Camping provision in the National Park and the Loch Achray campsite

The main flaws in the proposed Loch Achray campsite

CAMPING PITCH DESIGN

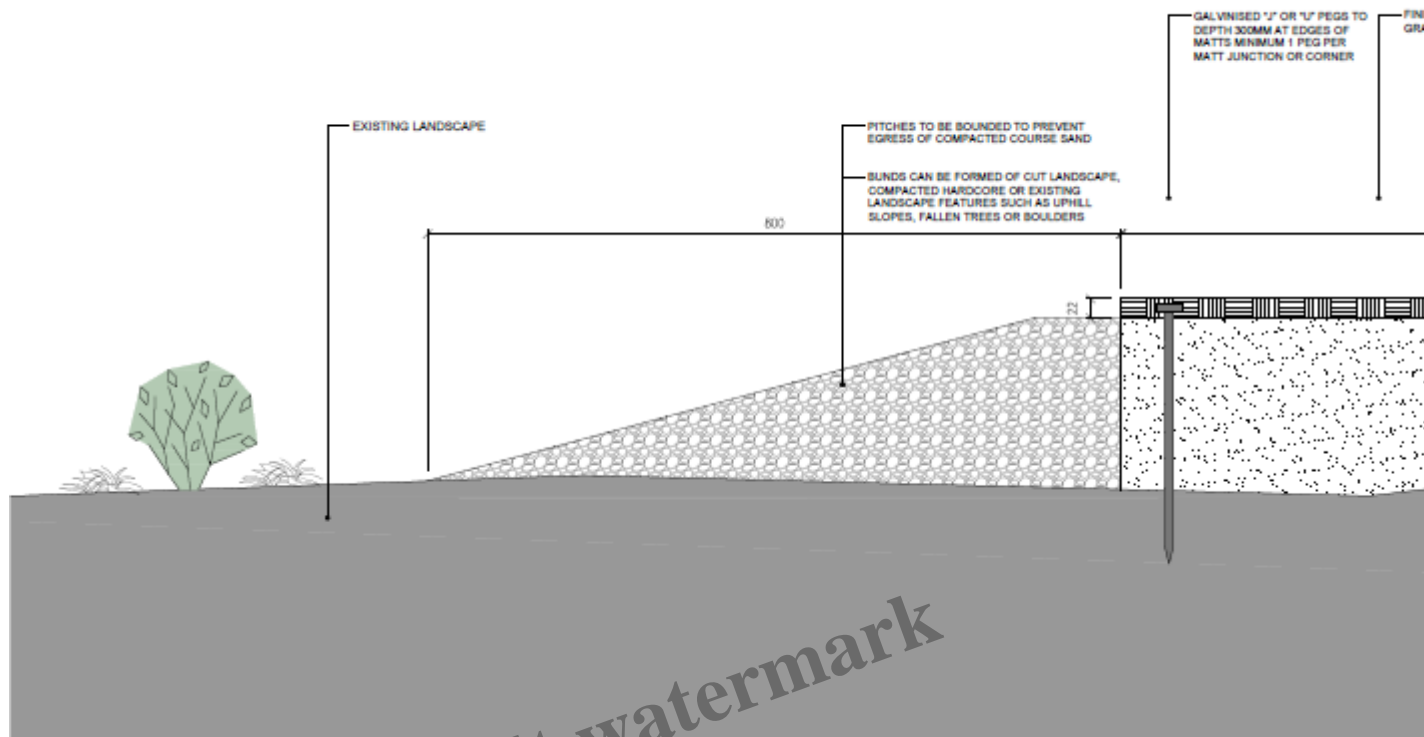
Camping on bark is horrible and describing it as traditional is simply "parkspeak". However, it appears that the current proposal is for rubber pitches on raised sand beds:

No-one from the Park appears to have asked any campers whether they like camping on artificial mats – although I guess if people were asked they might suggest their use on some of the sloping pebble beaches which the Park has designated as camping permit areas!

While some work might be required to create the 3 camping pitches on the west side of the burn, where the land is boggy and overgrown, this could be done without rubber matting. NO artificial pitches are needed in the largest camping area on the east side of burn.

2.3 Off Site Management / Resources

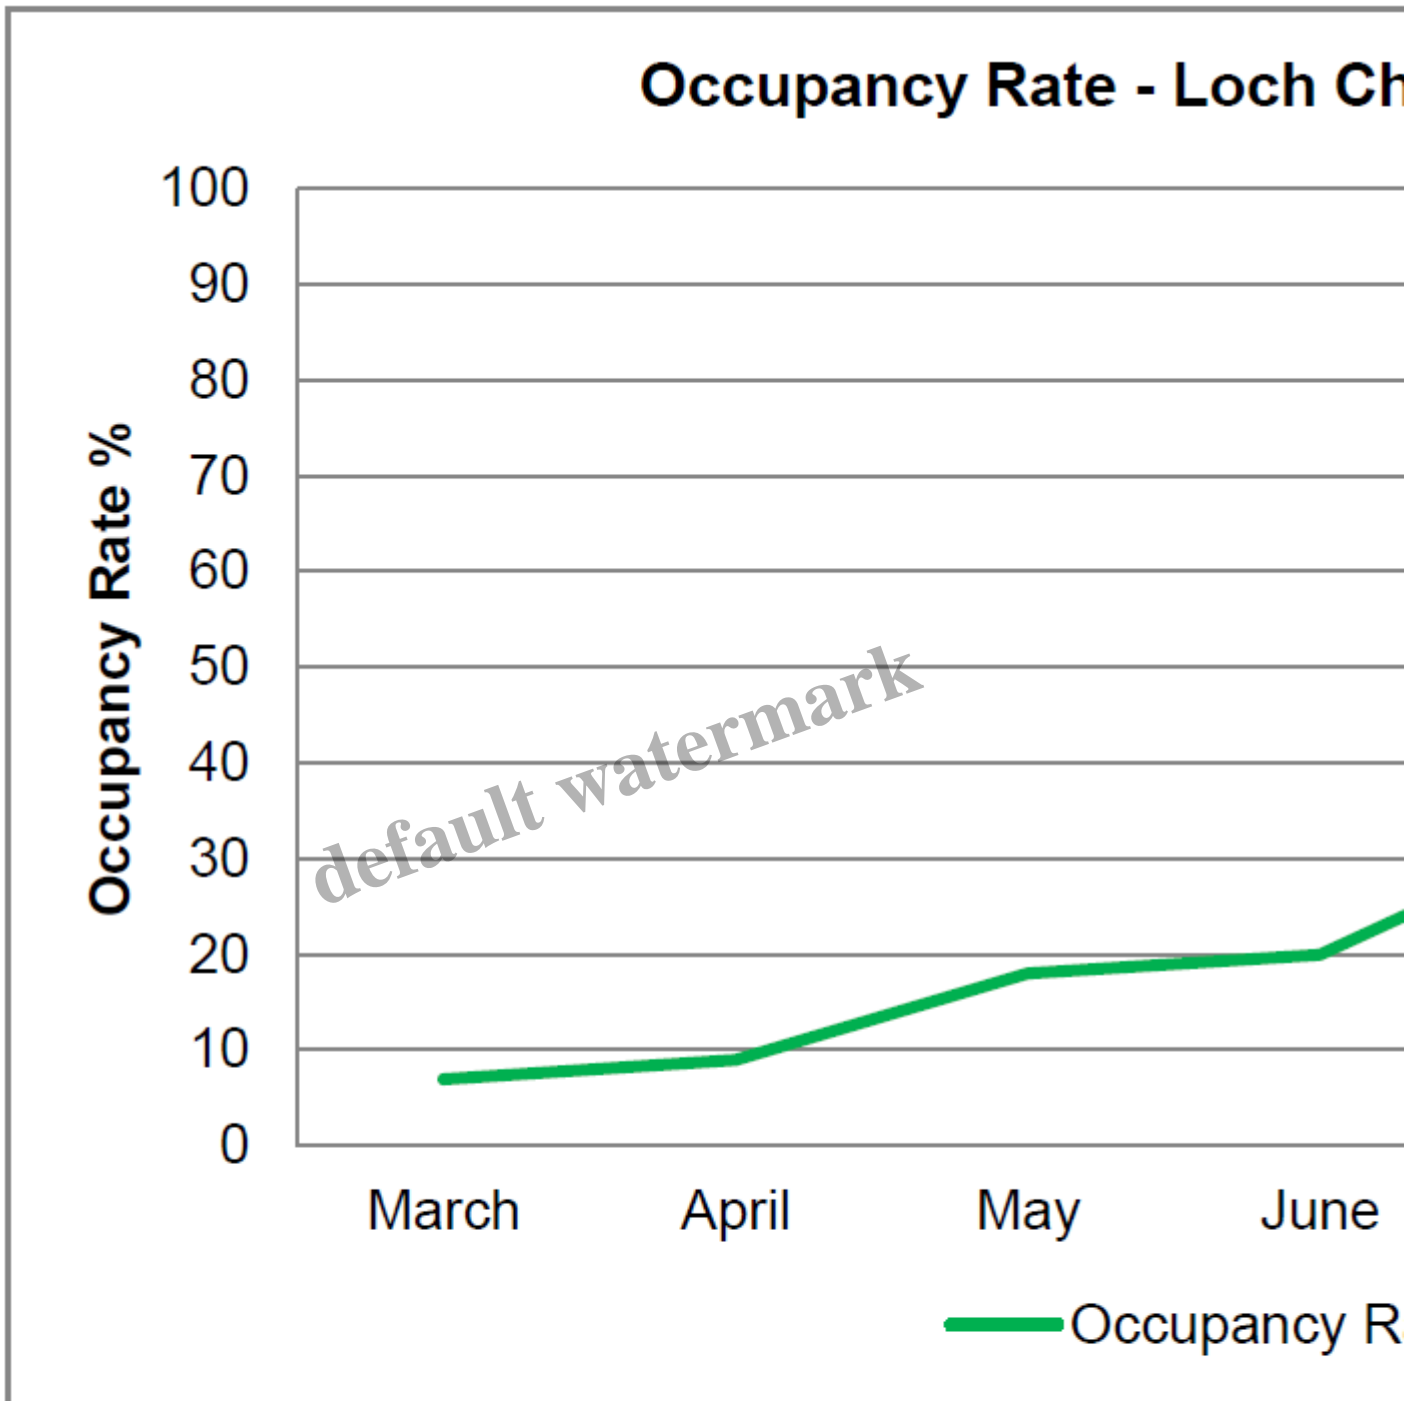
The Park also now appears to be proposing the campsite is staffed 10 hours a day:

This is madness which appears driven by the need to get SEPA to withdraw their objection. The Loch Achray site is actually much better and safer for camping than some of the camping permit areas created by the Park which are regularly underwater and unusable (e.g the beaches at Firkin Point). The difference though is the permit areas never required planning permission. More hypocrisy from the LITNPA and other agencies. Should SEPA not have been objecting to many of the permit areas because of their flood risk?

The cost implications of this staffing are significant. 10 hours at even £10 per hour (minimum wage plus on costs) is £100 a day. 17 places are planning and lets the campsite does twice as well as Loch Chon, which was always too big and is more remote and whose occupancy is as follows:
